addendum

No.	02	**Project:**	WCFPD Station 1
Date:	September 19, 2025	**Project No:**	025-2125

1 / A961 PARTIAL FINISH PLAN - WEST
3/16" = 1'-0"

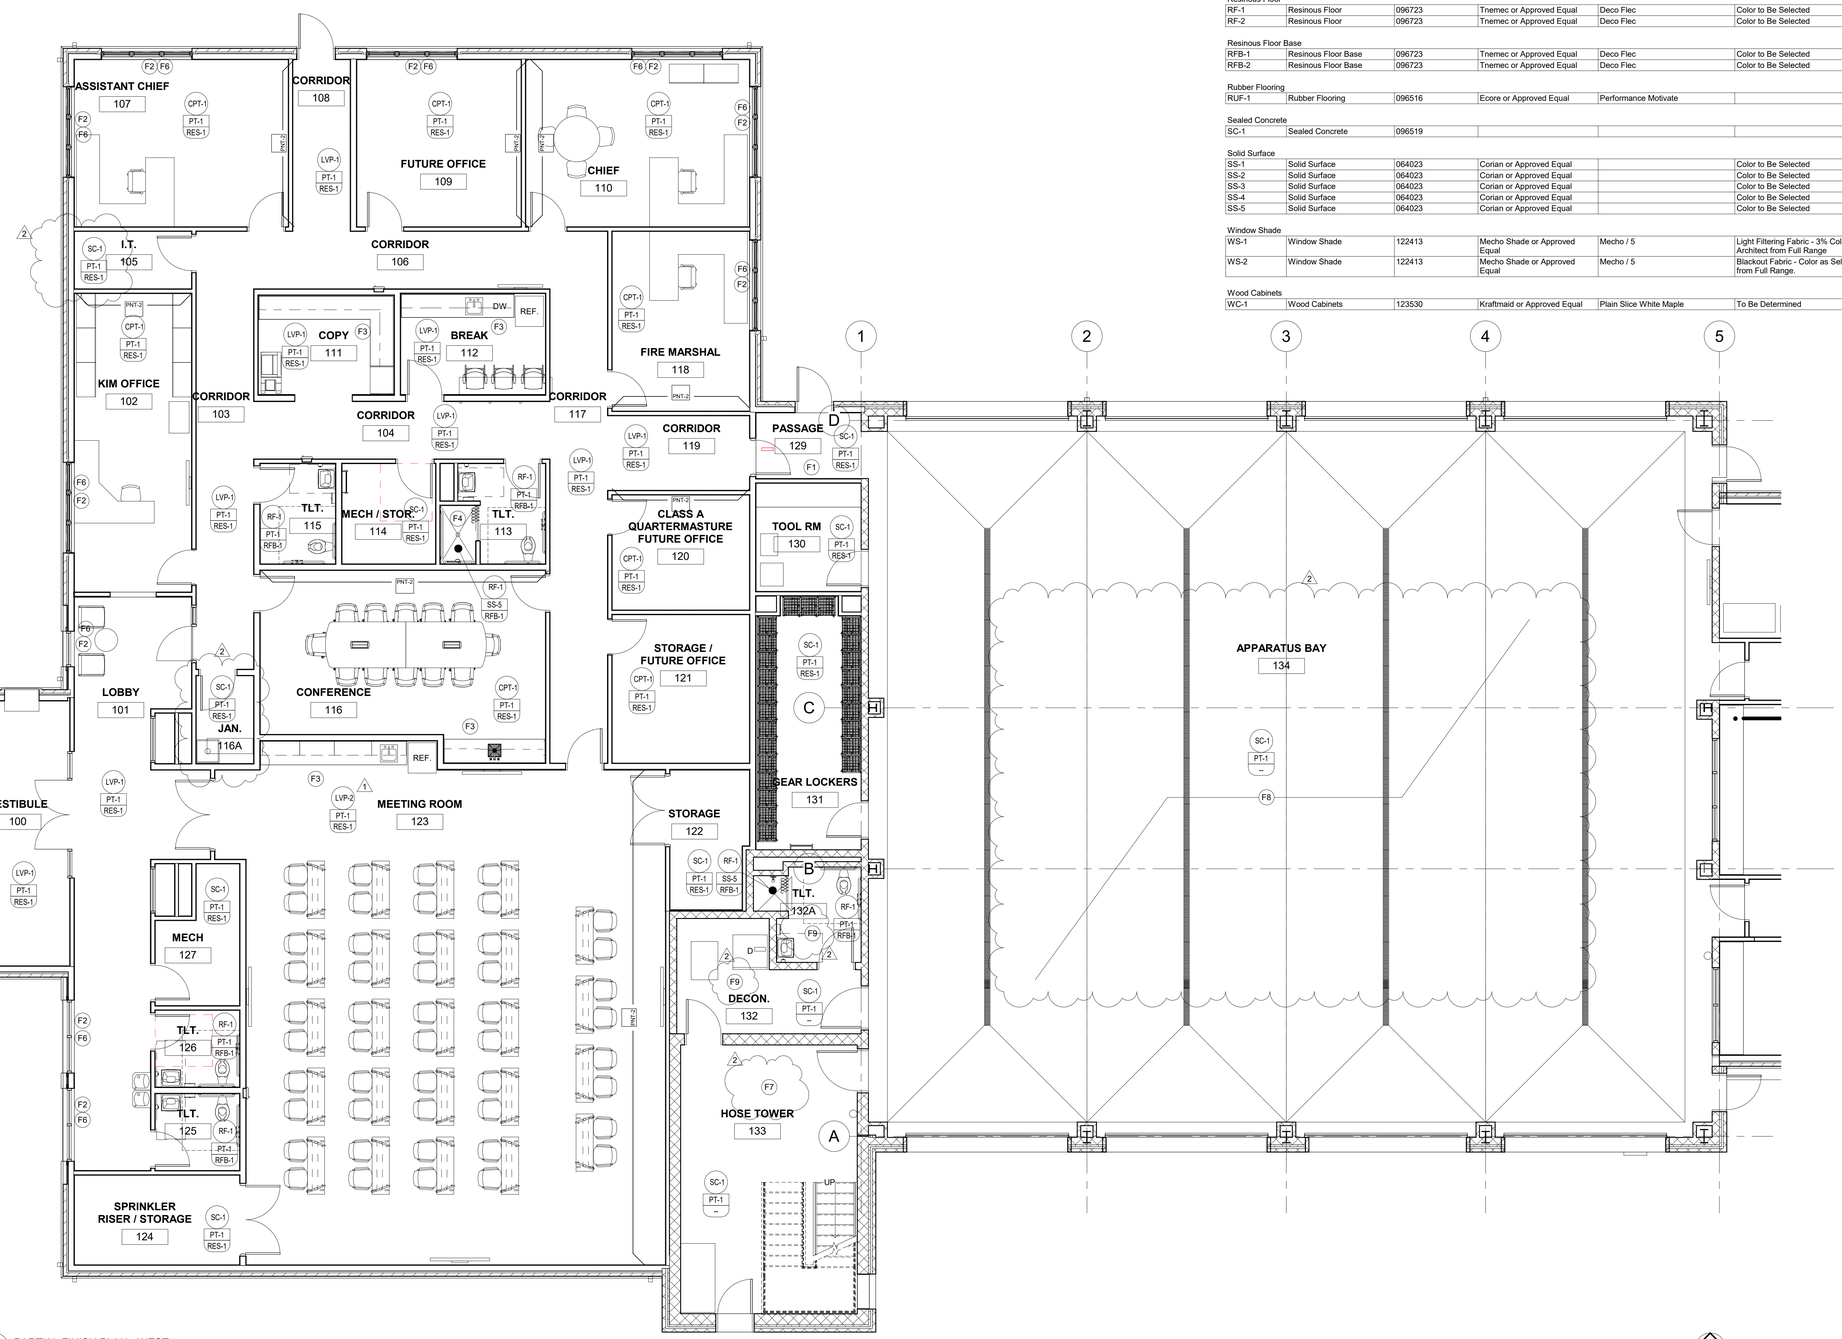
a. REVISE location of hose reel to coordinate with Plumbing documents.
23) Sheet A961 – PARTIAL ROOM FINISH PLAN (WEST) AND LEGEND
    a. ADD finish tags to rooms where they are missing.

b. ADD Keyed Notes F7, F8 and F9.
    c. REVISE HPL-3 to be for countertops
24) Sheet A962 – PARTIAL ROOM FINISH PLAN (EAST) AND LEGEND
    a. ADD finish tags to rooms where they are missing.

1 PARTIAL FINISH PLAN - EAST
A962 3/16" = 1'-0"

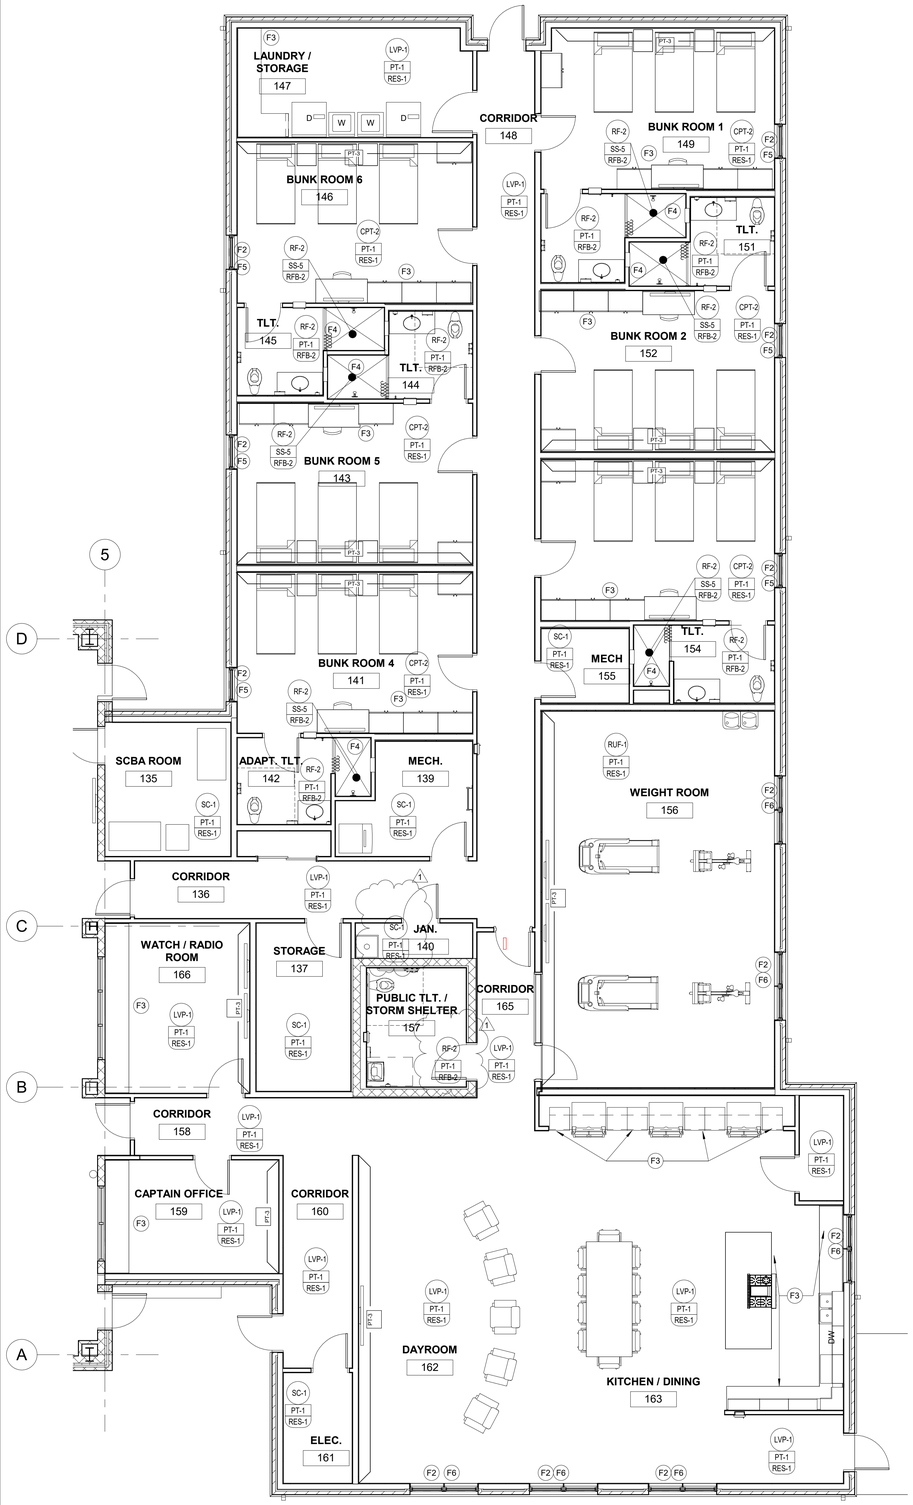
b. ADD Keyed Notes F7, F8 and F9.
    c. REVISE HPL-3 to be for countertops
25) Sheet S200 - FOUNDATION PLAN
    a. UPDATE slab note and add footing dimensions.

DESIGNED: GLL
DRAWN: SEH
PROJECT NO.: 250264
SHEET: S300

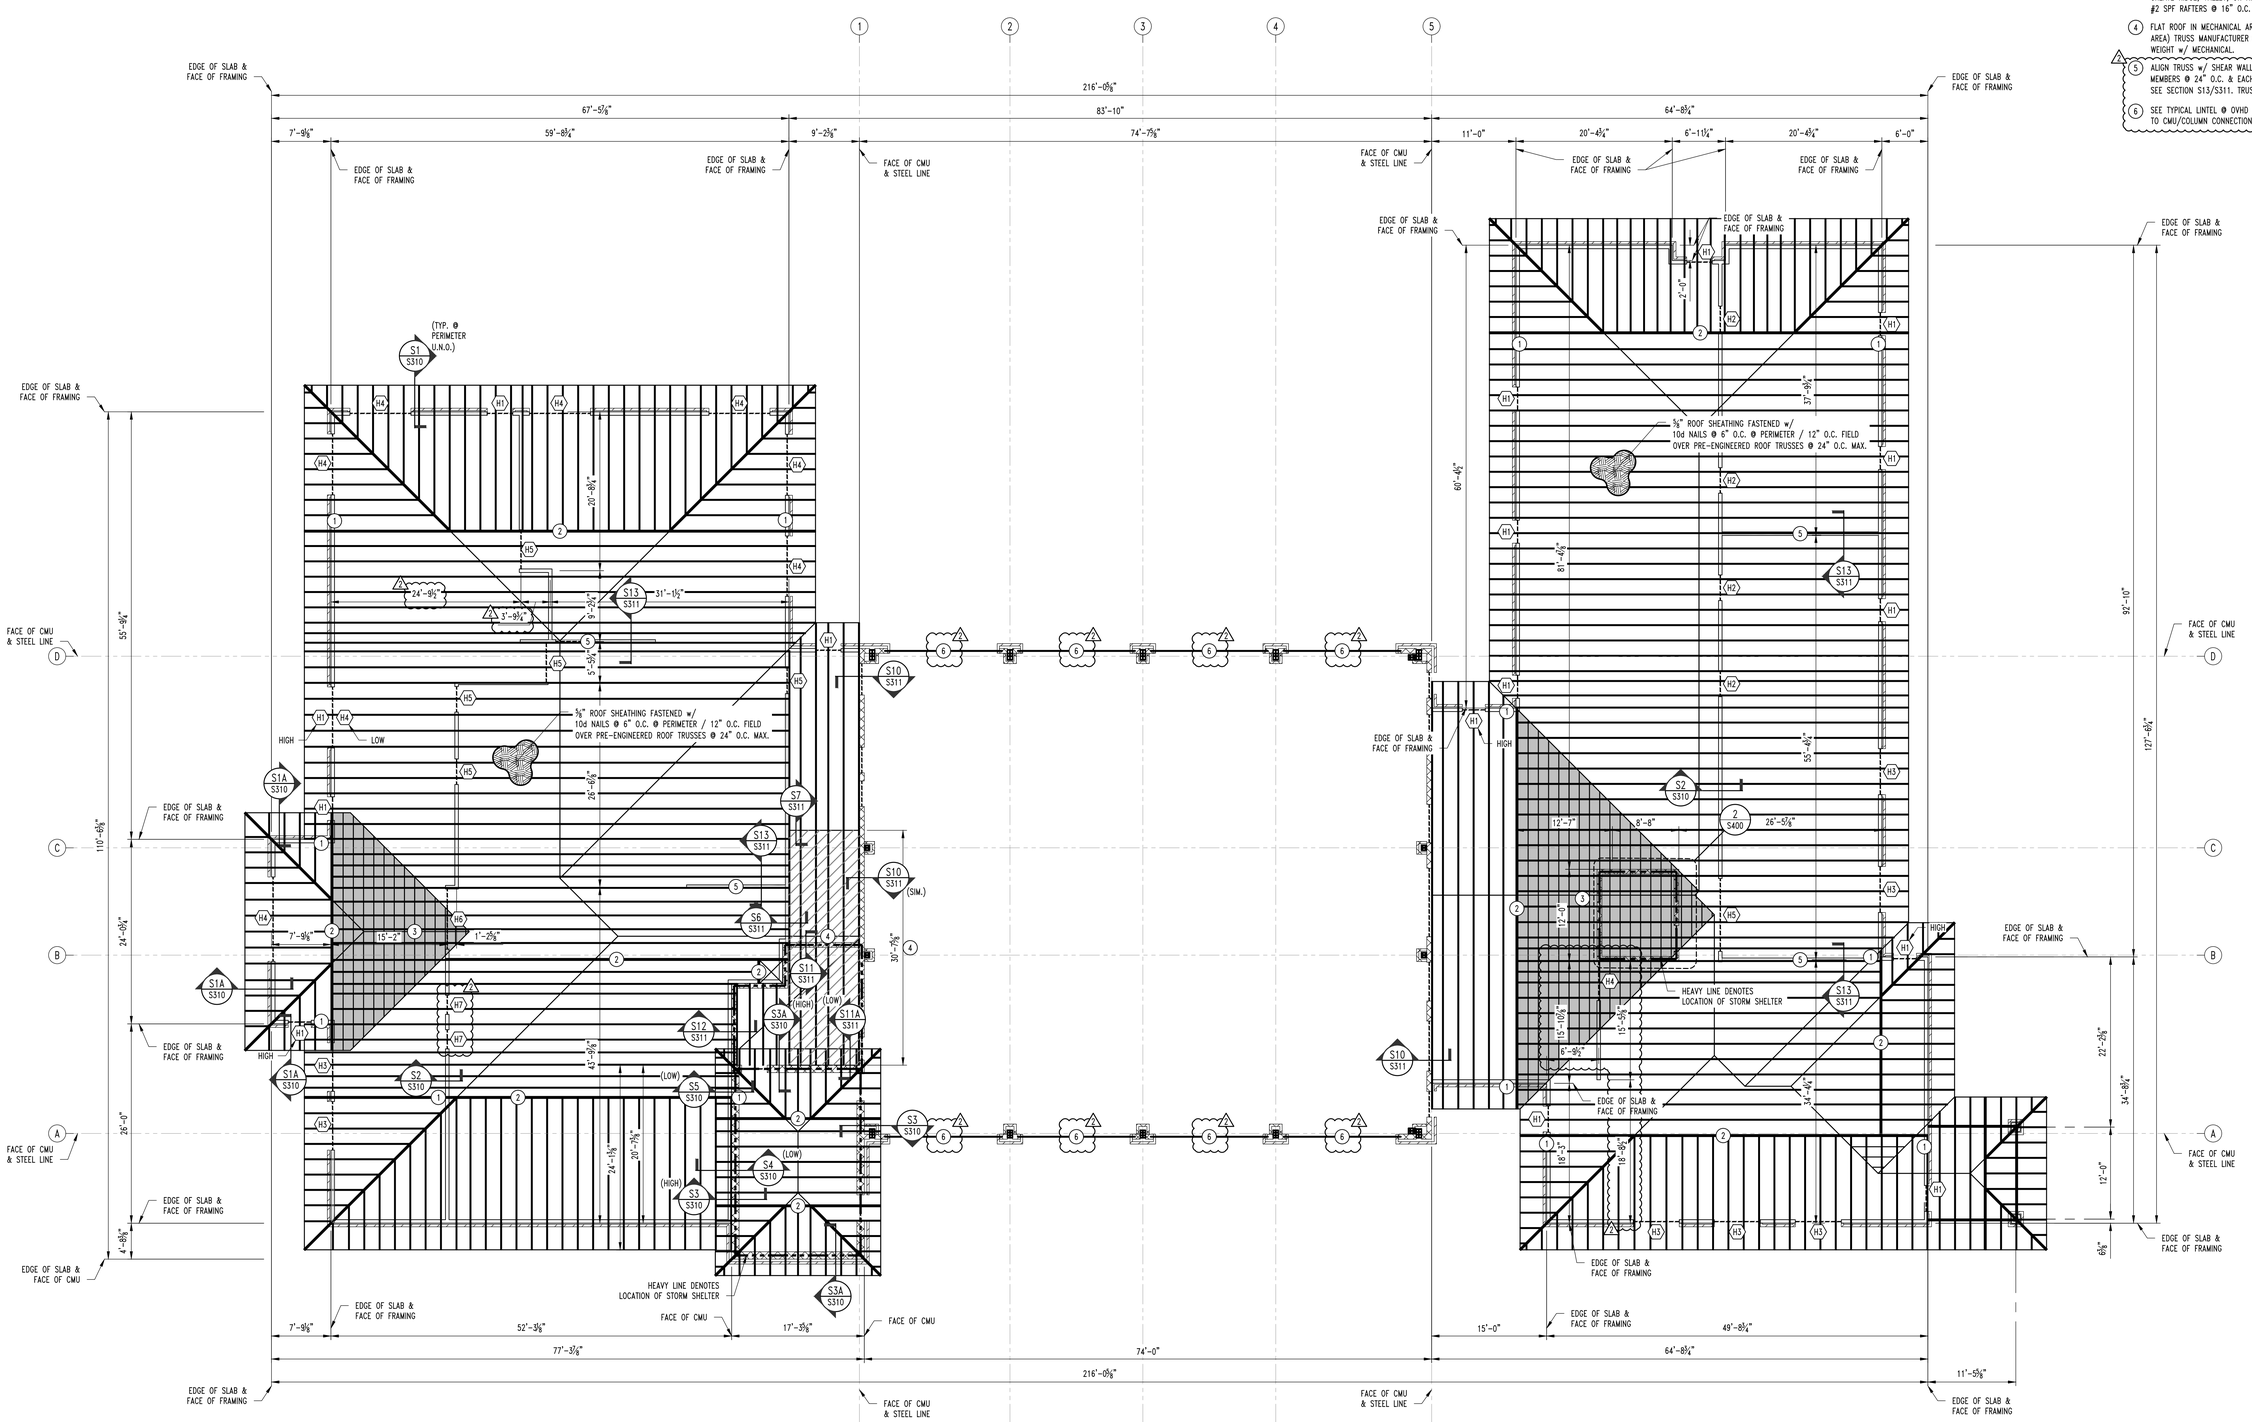
a. ADD framing notes #5 and #6.
    b. ADD two headers.
    c. UPDATE framing dimensions.

S10 / S300 **ROOF FRAMING SECTION**
SCALE: 1½" = 1'-0"

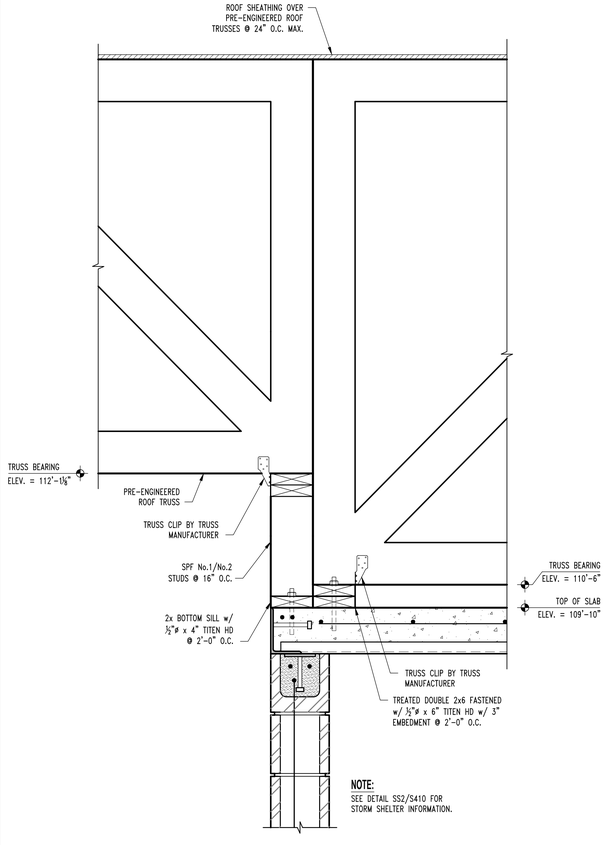
a. UPDATE Detail S10.
31) Sheet S312 – FRAMING AND STANDARD CMU DETAILS
    a. UPDATE Typ. Lintel to CMU/Column Connection, Typ. Lintel @ Overhead Doors and Typ. Hose Wheel Details.

SHEET:
S510

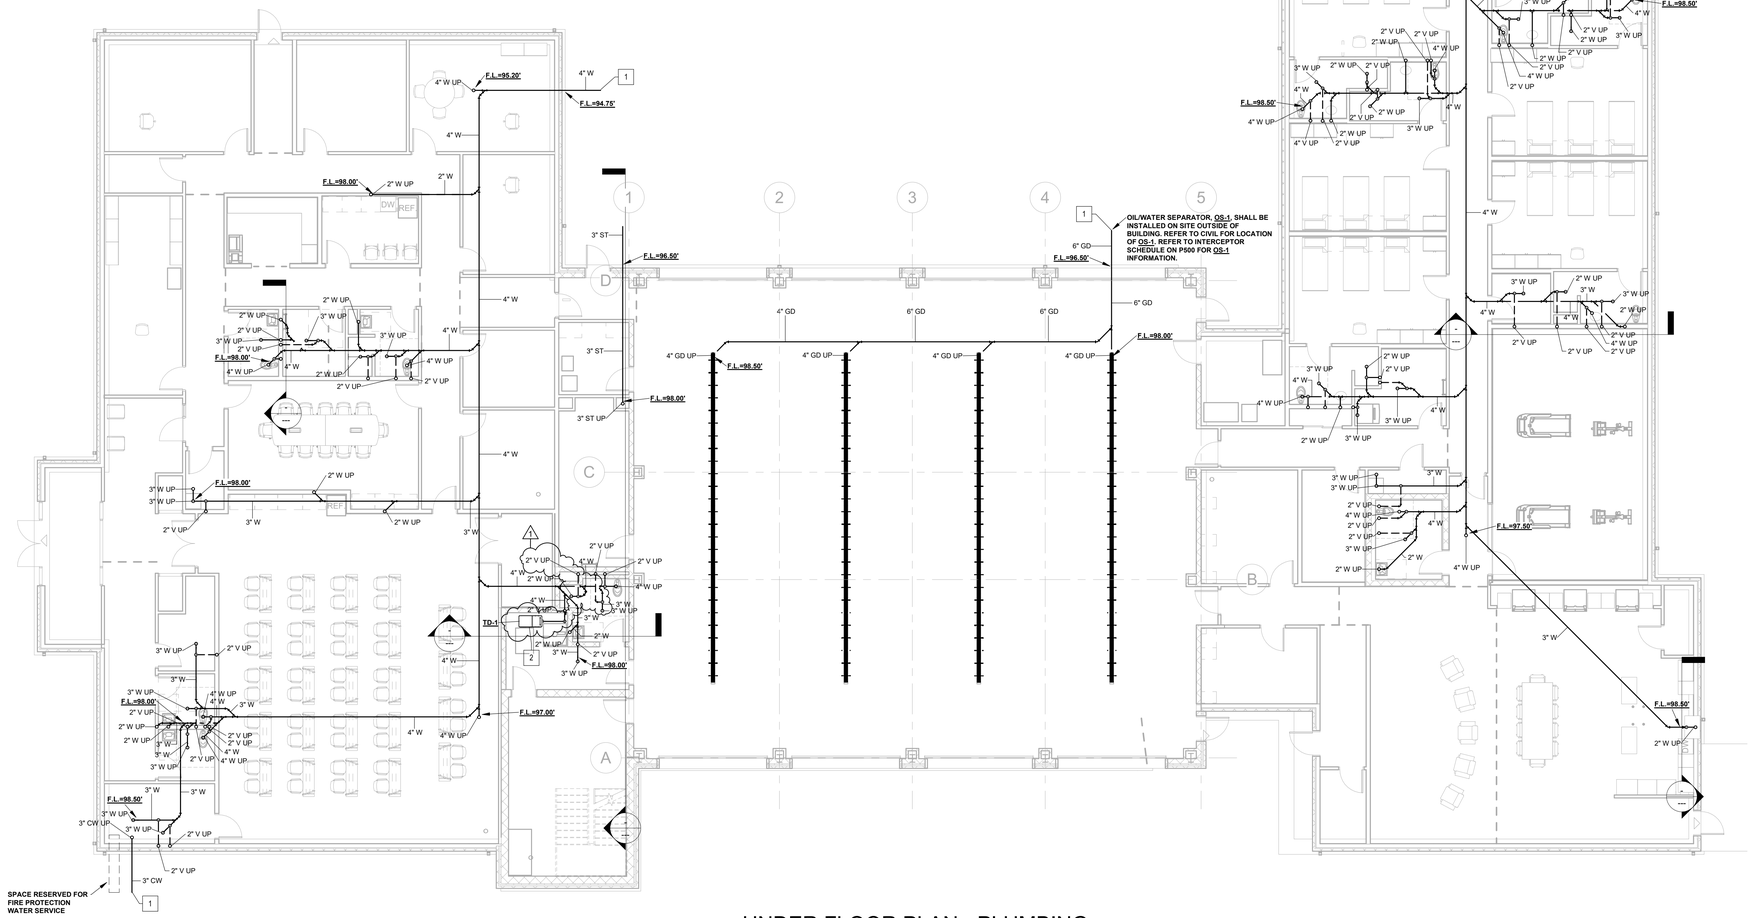
33) Sheet S510 – HOSE TOWER STAIR/MEZZANINE FRAMING DETAILS
    a. UPDATE Details ST5 and ST6.
34) Sheet P100 – UNDERFLOOR PLAN – PLUMBING
    a. ADD 2" waste and vent piping for shower in TLT. 132A.

2 FIRST FLOOR PLAN - PLUMBING
P200 1/8" = 1'-0"

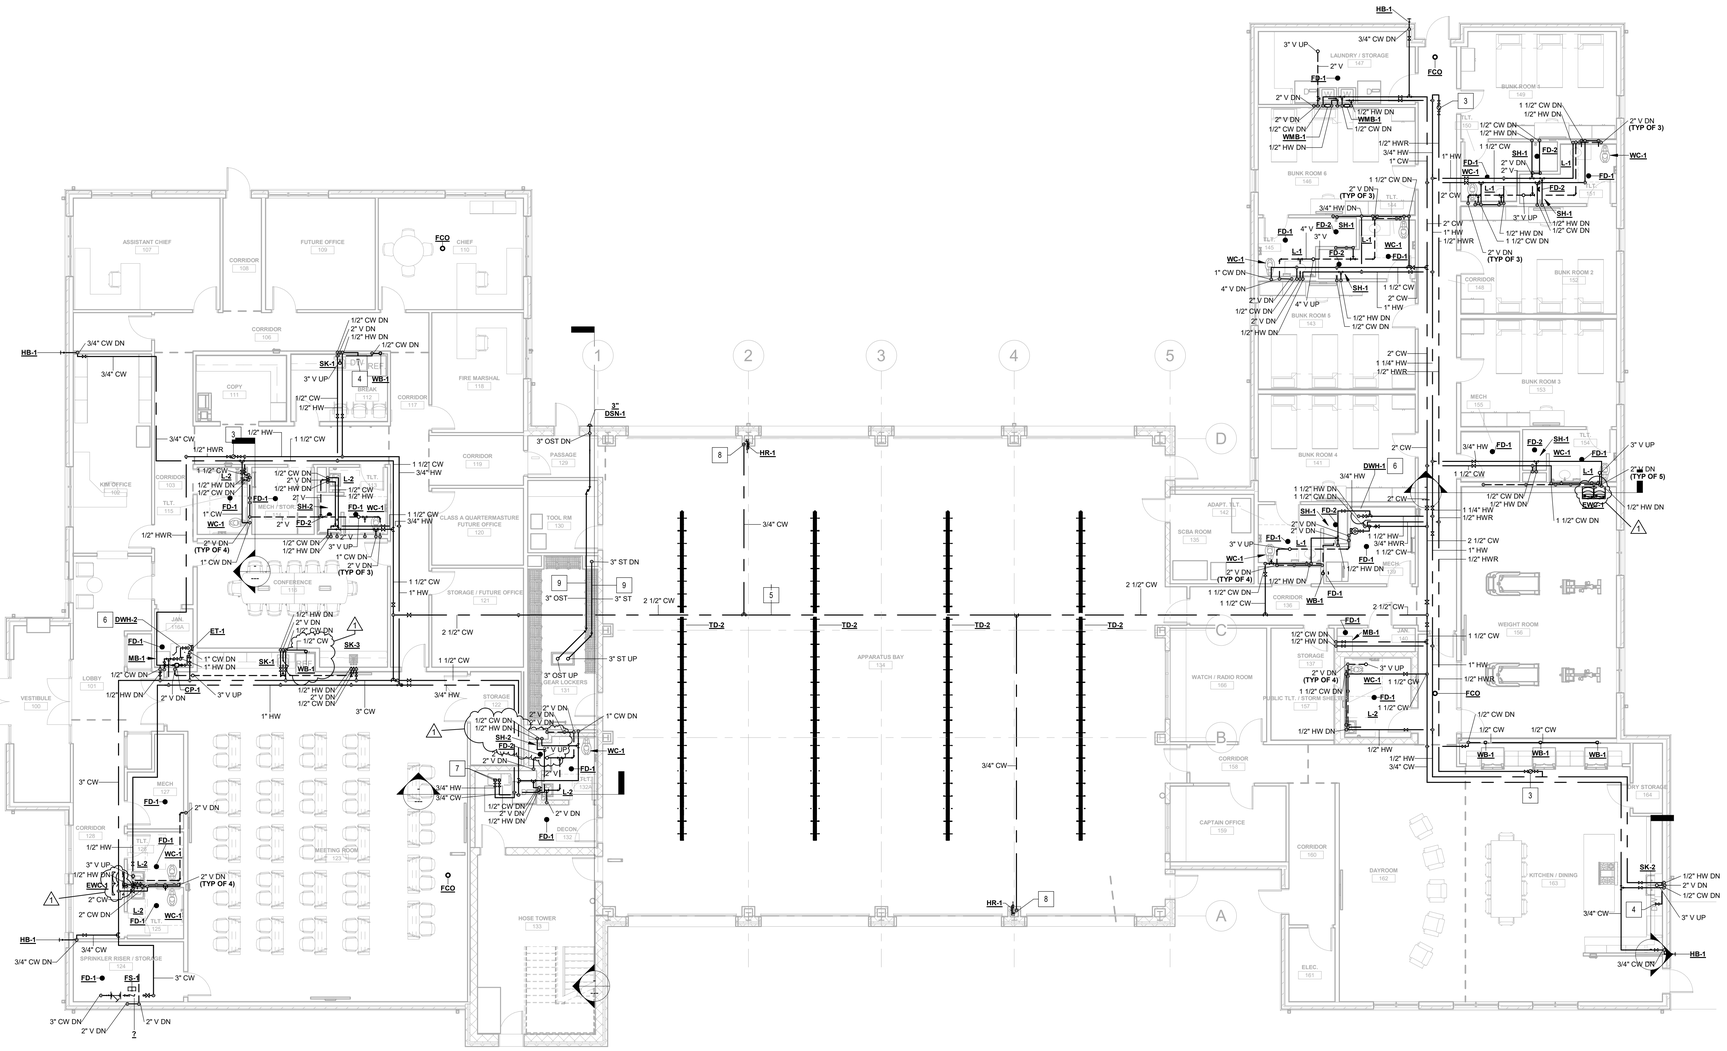
35) Sheet P200 – FIRST FLOOR PLAN – PLUMBING
    a. ADD FD-2 and SH-1 callouts with associated vent piping and cold water and hot water piping to shower in TLT. 132A.

b. REVISE plan to graphically show EWC-1 in Corridor 128.
    c. ADD WB-1 behind refrigerator with associated cold water piping in Meeting Room 123.

d. REVISE plan to graphically show EWC-1 in Weight Room 156.
36) Sheet P500 – SCHEDULES
    a. REVISE drain schedule to change TD-1 from a 4 foot long drain to a 3 foot long drain and change model from TT-4 to TT-3.
